Access Compliance Report

Public Rights-of-Way

(Curb Ramps)

Intersection ID: 48952	Main Street: BREVERA_CR	Cross Street: BONROI_AV	Location: S
ADA ID: 49072594F354	Ramp Type: Perp	Initial Pass/Fail: Pass	Overall Compliance: No
Severity Score: 0			
Codes/Mitigation Info/Possible Solution		Field Measurements/Component Compliance

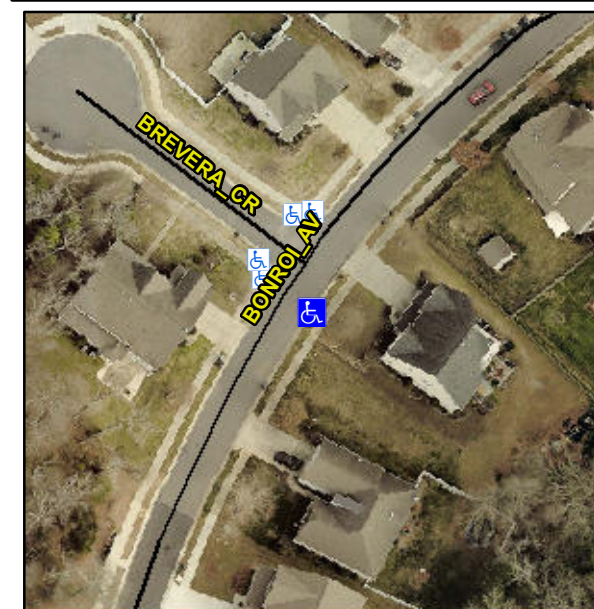
Not Found, R304.2.2-Perp, R304.3.2-Para

Compliance	Description	Data	Compliance	Description	Data
N/A	Ramp Length (in)	47.5	Yes	Ramp Slope (%)	6.7
Yes	Ramp Width (in)	48.5	Yes	Ramp XSlope (%)	1.8
N/A	Flare Type LT	Sloped	N/A	Flare Type RT	N/A
N/A	Flare Slope LT (%)	3.1	N/A	Flare Slope RT (%)	6.1
N/A	Flare Traversable LT?	No	N/A	Flare Traversable RT?	No
Yes	Landing Length (in)	58.5	Yes	DWS Provided?	Yes
Yes	Landing Width (in)	50.5	Yes	DWS Contrast?	Yes
No	Landing Slope (%)	2.2	Yes	DWS Length (in)	24.4
Yes	Landing X Slope (%)	1.6	Yes	DWS Full Width?	Yes
N/A	Landing Curb? (Y/N)	No	Yes	DWS Offset (in)	0.0
N/A	Shared Landing?	No			
Yes	Gutter Ponding?	No	Yes	Gutter Slope (%)	2.3
Yes	Gutter Lip Ht (in)	0.0	Yes	Gutter X Slope (%)	1.7
N/A	Painted X Walk1?	No	N/A	Painted X Walk2?	N/A
	X Walk 1 Direction	To W		X Walk 2 Direction	N/A
N/A	X Walk 1 Width (in)	N/A	N/A	X Walk 2 Width (in)	N/A
	X Walk 1 Slope (%)	4.9		X Walk 2 Slope (%)	N/A
	X Walk 1 X Slope (%)	1.2		X Walk 2 X Slope (%)	N/A

N/A	Ramp inside XWalk1?	N/A	N/A	Ramp inside XWalk2?	N/A
	Road Slope (%)	N/A	N/A	Clear Space?	Yes
	Road X Slope (%)	N/A	N/A	Clear Space to XWalk (in)	N/A
Yes	Any Obstructions?	No	Yes	Storm Grate/Utility Hazard?	No
	Obstruction Type			Storm Grate/Utility Type	
		N/A			N/A
			Yes	Surface Condition? (G/P)	Good

Remove & Replace Entire Ramp.
